Access Compliance Report

Public Rights-of-Way

(Curb Ramps)

Intersection ID: 11786	Main Street: E_17TH_ST	Cross Street: N_MCDOWELL_ST	Location: E
ADA ID: 2E747BEA89E5	Ramp Type: Perp	Initial Pass/Fail: Fail	Overall Compliance: No
		Severity Score: 72.5

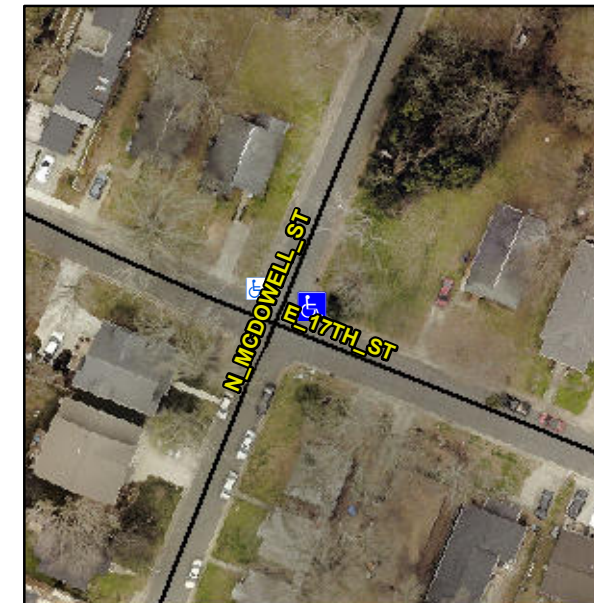
Not Found, R304.5.1, R304.2.2, R304.5.3

Compliance	Description	Data	Compliance	Description	Data
N/A	Ramp Length (in)	64.0	No	Ramp Slope (%)	12.5
No	Ramp Width (in)	28.0	No	Ramp XSlope (%)	5.2
N/A	Flare Type LT	N/A	N/A	Flare Type RT	N/A
N/A	Flare Slope LT (%)	N/A	N/A	Flare Slope RT (%)	N/A
N/A	Flare Traversable LT?	N/A	N/A	Flare Traversable RT?	N/A
N/A	Landing Length (in)	N/A	N/A	DWS Provided?	N/A
N/A	Landing Width (in)	N/A	N/A	DWS Contrast?	N/A
N/A	Landing Slope (%)	N/A	N/A	DWS Length (in)	N/A
N/A	Landing X Slope (%)	N/A	N/A	DWS Full Width?	N/A
N/A	Landing Curb? (Y/N)	N/A	N/A	DWS Offset (in)	N/A
N/A	Shared Landing?	N/A			
N/A	Gutter Ponding?	N/A	N/A	Gutter Slope (%)	N/A
N/A	Gutter Lip Ht (in)	N/A	N/A	Gutter X Slope (%)	N/A
N/A	Painted X Walk1?	No	N/A	Painted X Walk2?	N/A
	X Walk 1 Direction	To NW		X Walk 2 Direction	N/A
N/A	X Walk 1 Width (in)	N/A	N/A	X Walk 2 Width (in)	N/A
	X Walk 1 Slope (%)	2.3		X Walk 2 Slope (%)	N/A
	X Walk 1 X Slope (%)	1.9		X Walk 2 X Slope (%)	N/A

Remove & Replace Entire Ramp.
